# Access Compliance Report

## Public Rights-of-Way

### (Curb Ramps)

Intersection ID: 4659	Main Street: ASTORIA_DR	Cross Street: HARRIS_HOUSTON_RD	Location: W
ADA ID: 7C4FABBCFB76	Ramp Type: Perp	Initial Pass/Fail: Fail	Overall Compliance: No
Severity Score: 37.5			
Codes/Mitigation Info/Possible Solution		Field Measurements/Component Compliance

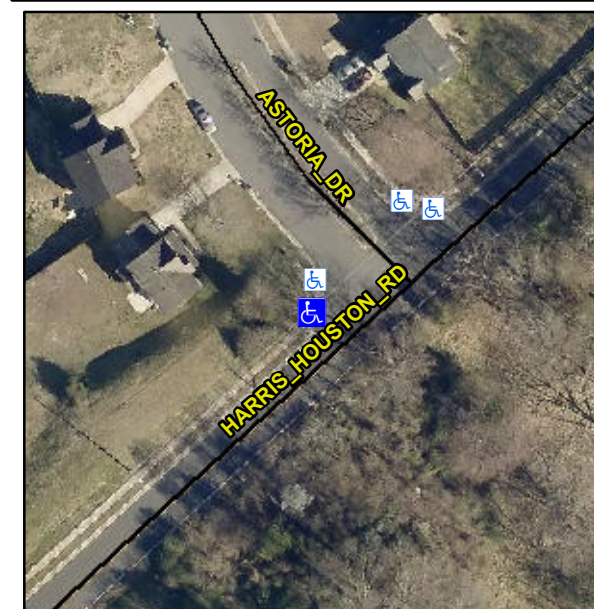
**Remove & Replace Entire Ramp.**

**R304.2.2, R304.5.3**

Compliance	Description	Data	Compliance	Description	Data
N/A	Ramp Length (in)	96.0	No	Ramp Slope (%)	8.6
Yes	Ramp Width (in)	48.0	No	Ramp XSlope (%)	15.0
N/A	Flare Type LT	N/A	N/A	Flare Type RT	N/A
N/A	Flare Slope LT (%)	N/A	N/A	Flare Slope RT (%)	N/A
N/A	Flare Traversable LT?	N/A	N/A	Flare Traversable RT?	N/A
N/A	Landing Length (in)	N/A	N/A	DWS Provided?	N/A
N/A	Landing Width (in)	N/A	N/A	DWS Contrast?	N/A
N/A	Landing Slope (%)	N/A	N/A	DWS Length (in)	N/A
N/A	Landing X Slope (%)	N/A	N/A	DWS Full Width?	N/A
N/A	Landing Curb? (Y/N)	N/A	N/A	DWS Offset (in)	N/A
N/A	Shared Landing?	N/A			
N/A	Gutter Ponding?	N/A	N/A	Gutter Slope (%)	N/A
N/A	Gutter Lip Ht (in)	N/A	N/A	Gutter X Slope (%)	N/A
N/A	Painted X Walk1?	No	N/A	Painted X Walk2?	N/A
	X Walk 1 Direction	To SE		X Walk 2 Direction	N/A
N/A	X Walk 1 Width (in)	N/A	N/A	X Walk 2 Width (in)	N/A
	X Walk 1 Slope (%)	3.9		X Walk 2 Slope (%)	N/A
	X Walk 1 X Slope (%)	14.8		X Walk 2 X Slope (%)	N/A
